Appendix F

Public Comment Letters

Subject: Round Mountain Expansion Project Draft Environmental Impact Statement
(EIS), Nye County, Nevada [CEQ # 20090256]

Figure 1: Snapshot of portion of DEIS 3.3-19 showing geologic in the Round Mountain pit. The vertical grid is 1000 feet.

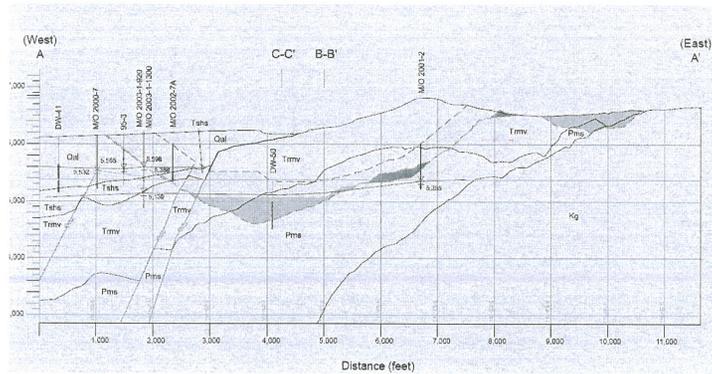
9-13 Figures 1 and 2, comparing the relevant geologic and model cross-sections near the Round Mountain Mine as published in the DEIS, demonstrate various errors made by WMC in their representation of the layers near the pit. For example, the pit will intersect the Kg formation (Figure 1) but the pit will excavate only model layer 1 as shown in Figure 2. None of the layers simulate properly the Tsts formation (Figure 1).

- 9-15 (cont'd) The Stebbins Hill formation thickness ranges from about 100 to 300 feet (Figure 1), which is much thicker than layer 2 (Figure 2). It is also not clear how the model simulates the Stebbins Hill formation pinching out within the pit area.

- 9-18 WMC’s layer design combined with their methodology for modeling the pit would cause much of the bedrock flow to go underneath the forming pit. DEIS Figure 3.3-19 (Figure 1) shows clearly that pit does or will intersect formations Qal, Trmv, and Pms. The latter two formations dip sharply to the west. WMC Figure 7.14 (or DEIS Figure 4.3-4, Figure 2) suggests the pit will be constructed just in layer 1⁶. The discussion below considers that WMC uses hydraulic parameters for the pit only in layer 1. The layers as constructed therefore cause the groundwater flow to plunge beneath the pit which may limit the amount of dewatering simulated by the model.

9-13 The Stebbins Hill Formation (Figure 3.3-19 of the EIS) is incorporated into Layer 2 of the groundwater model. The hydraulic conductivity distribution in Layer 2 reflects the geologic location of the Stebbins Hill Formation.

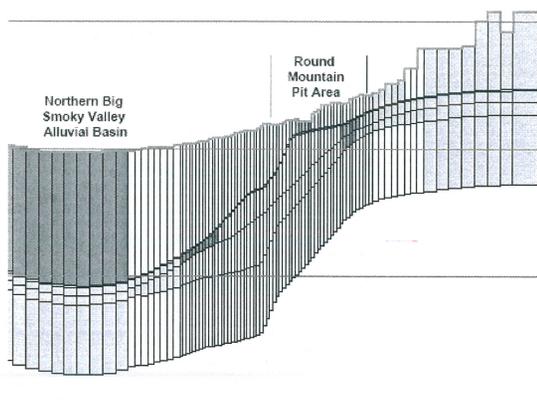
9-14 *Layer 1* represents basin fill wherever it exists. In the middle of the valley it is over 3000 feet thick; the model simulates it as 2000 feet thick west of the Round Mountain pit (Figure 2). This prevents the model from simulating vertical gradients within the basin fill because a single layer effectively has the same head throughout the cell. This is an inaccurate depiction of ET discharge, and the conceptual model, because water that recharges in the mountains and valley edges flows vertically downward and then toward the middle of the valley. It then flows upward to discharge as ET at the surface. It would be more accurate to use several layers to simulate the changing gradient within the fill.

9-15 *Layer 2* is very thin across the entire domain but because of its very low conductivity has a large, inappropriate effect on flow in the model. There is no hydrostratigraphic formation it could represent across the entire valley (Figure 1). WMC may have intended layer 2 near the Round Mountain pit to be

9-15 Layer 2 hydraulic conductivity zones are shown in Figure 7.10 of WMC (2008). This figure shows the extent of the Stebbins Hill Formation by the area of low hydraulic conductivity values of 2.0×10^{-5} feet/day. The Sinter Unit at Gold Hill is included in this zone of low hydraulic conductivity for Layer 2. Thus, the low hydraulic conductivity zone in Layer 2 west of the Round Mountain/Gold Hill area is designed to represent the Stebbins Hill Formation and Sinter Unit in the model. The thickness of Layer 2 does not exactly match the thickness of the Sinter Unit or Stebbins Hill Formation, but the combination of the thickness and the hydraulic conductivity is designed to represent the transmissivity of both units. Outside of the geologic extent of the Stebbins Hill Formation, Layer 2 is "a dummy layer" in that it has the same hydraulic parameters as the layer underlying it.
